Addendum No.: 5

Date Of Addendum: 7/12/2019

Energy Upgrades  
Greater Bridgeport Community Mental Health Center  
1635 Central Avenue  
Bridgeport, CT  
BI – MH – 111

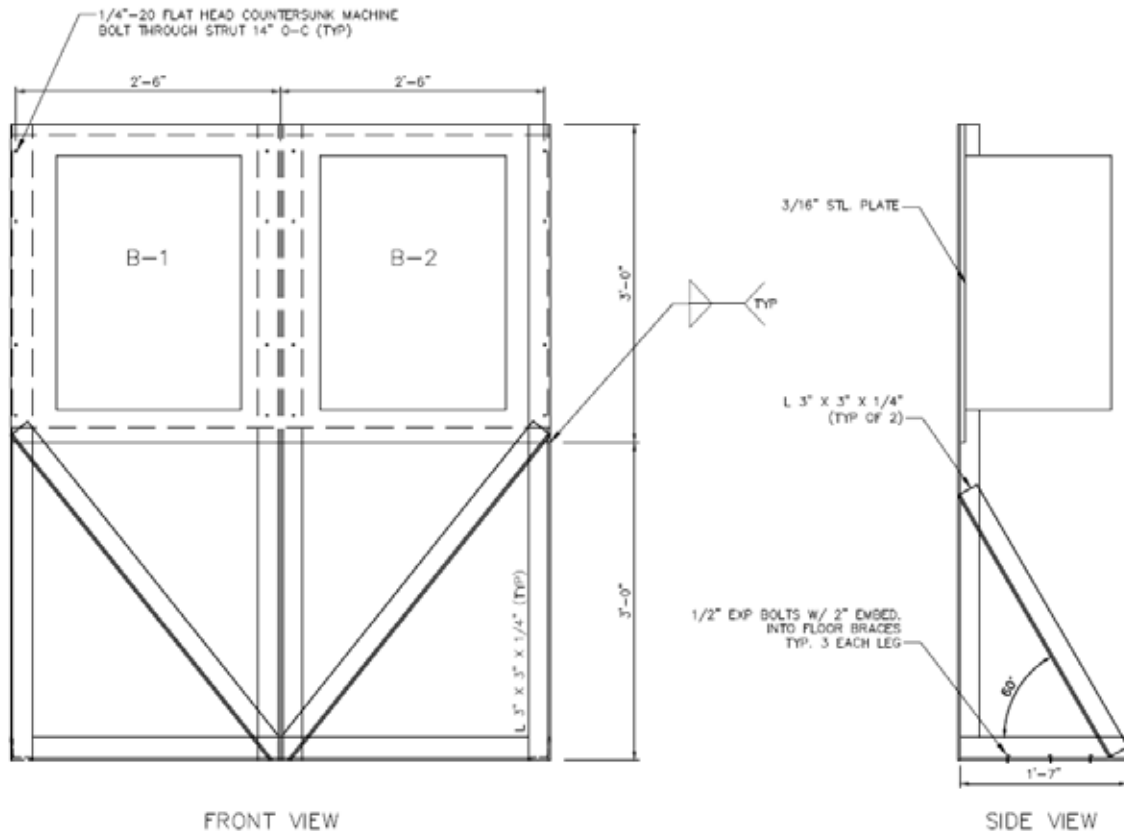
Question: Regarding the metal frame for the ground floor boiler support, can we utilize Unistrut in lieu of welding an angle iron frame together?

Response: No. Unistrut is not suitable for this design. The supports should be modified as below.

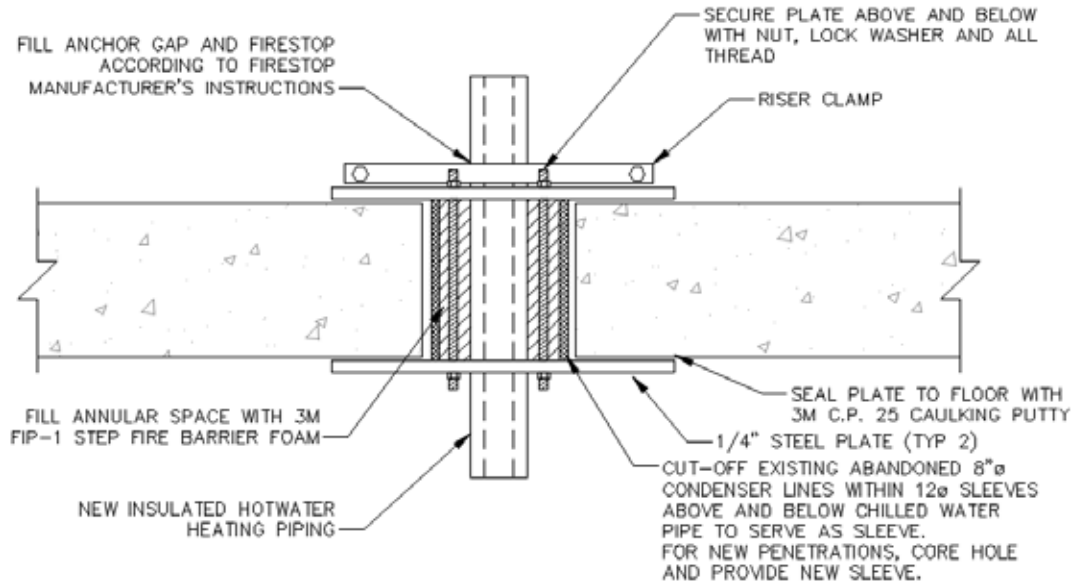
Question: Please provide a detail for the firestopping penetrations, specifically the abandoned 12" steam and condensate line to the new 4" or less hot water supply and return lines?

Response: See sketch below. Existing abandoned pipes currently run floor to ceiling.
